Construction Documentation Report

Landfill Gas Collection and Control System Expansion 2011

Johnston County Landfill (Permit# 51-03)

I have completed a review of the revised Construction Document Report (Report). There are several “typos” or data missing in the As-built drawings which are described below:

SHEET: 9 OF 12
CAD FILE: ASBUILTS.DWG
PROJECT NO: 110065

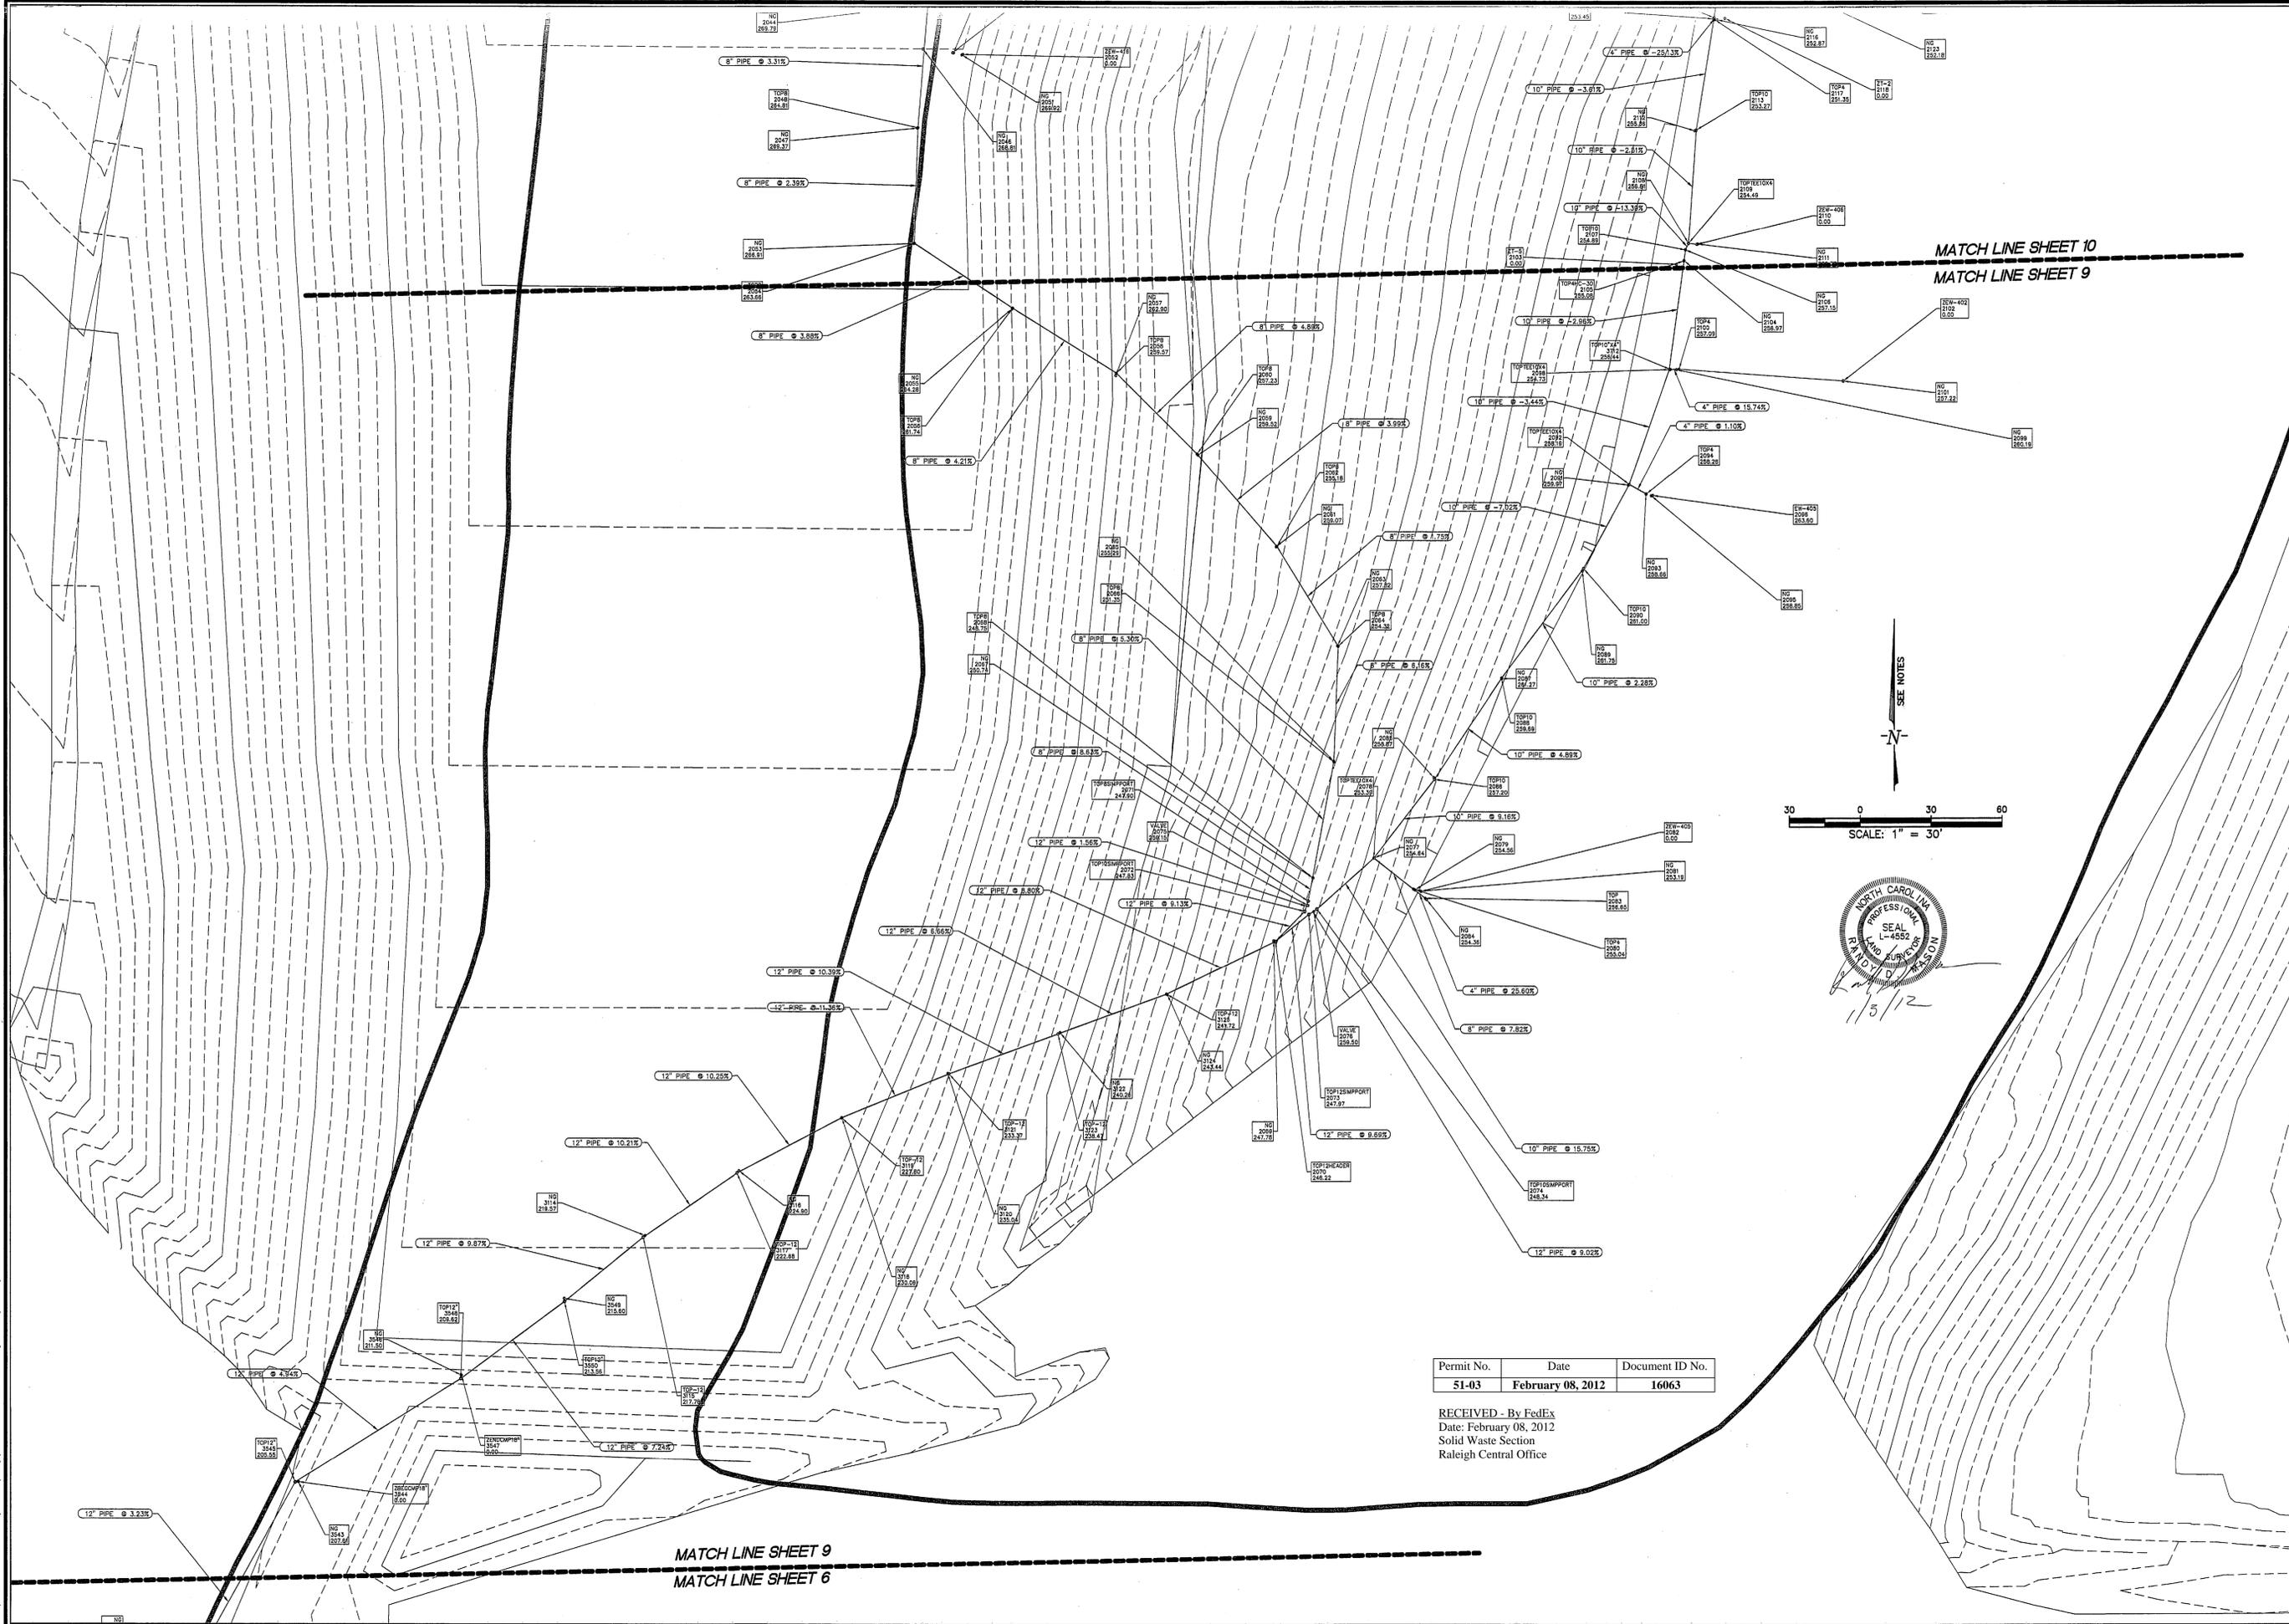
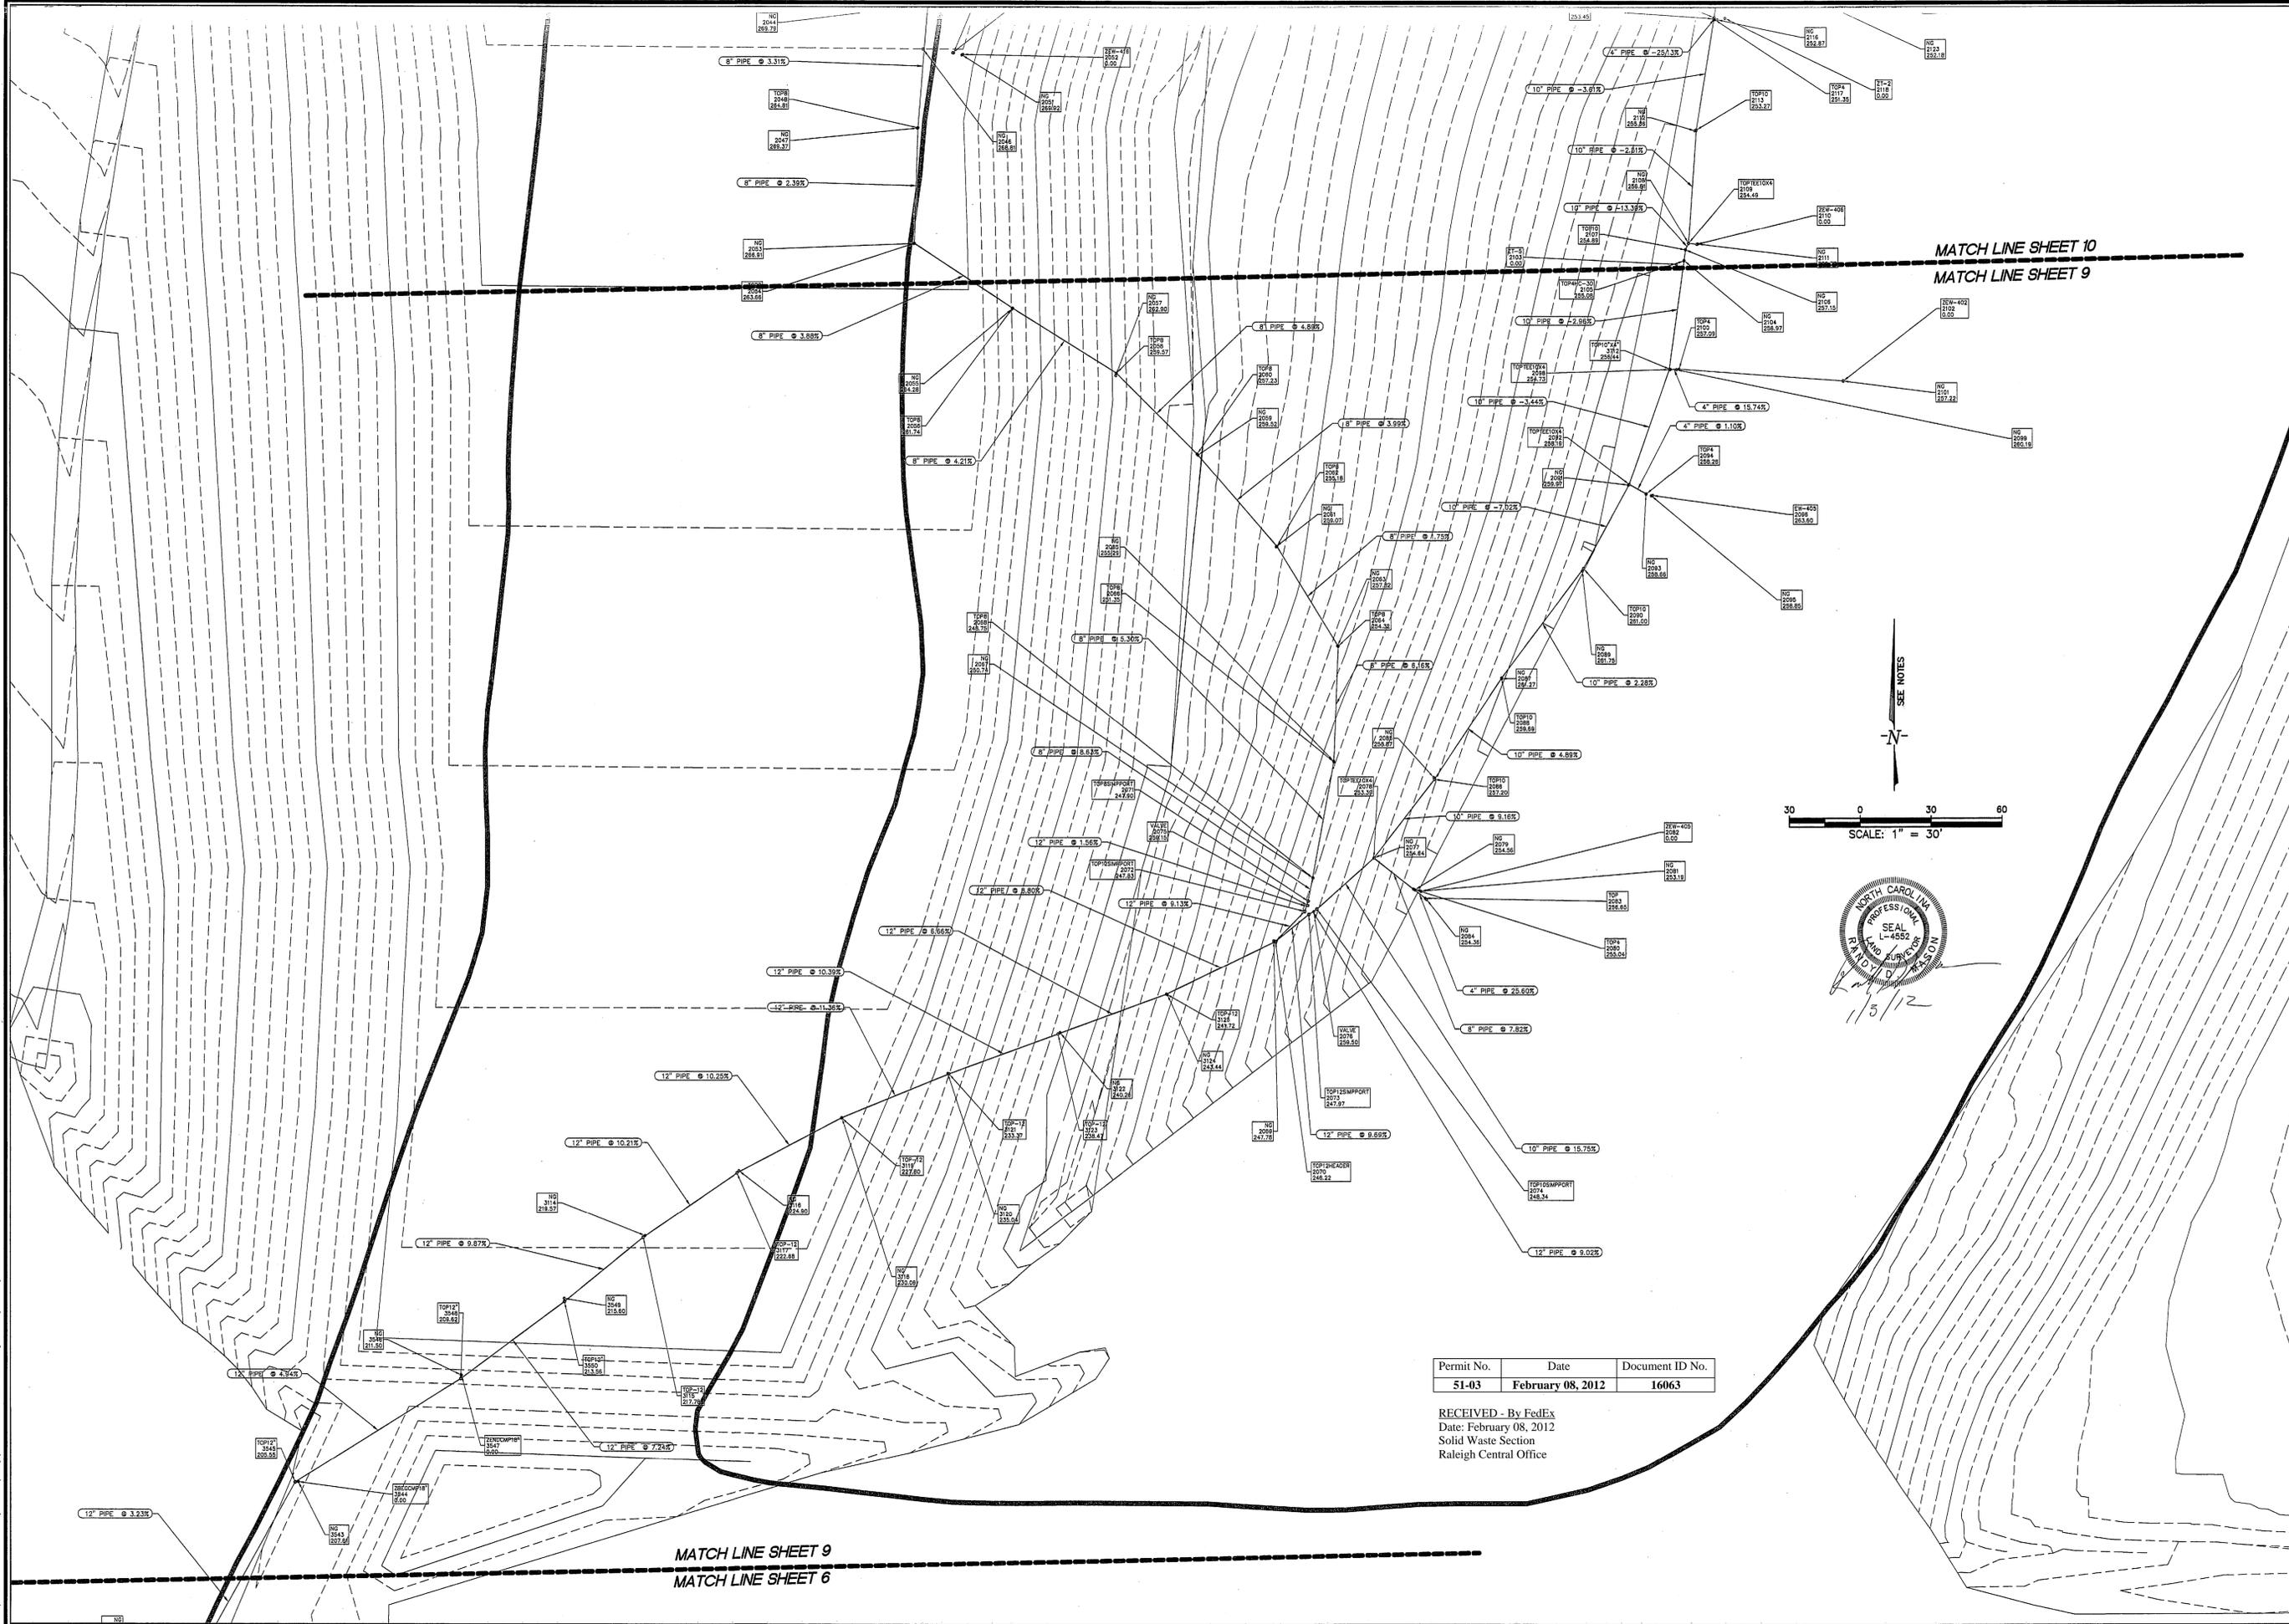
1. (Sheet 9 of 12) There are two locations have the same identification number-ZEW-405. To avoid confusion please change the one with other identification number and keep the ZEW-405 for the well EW-405 or make a “field note” in the drawing to eliminate any potential confusion in the future.
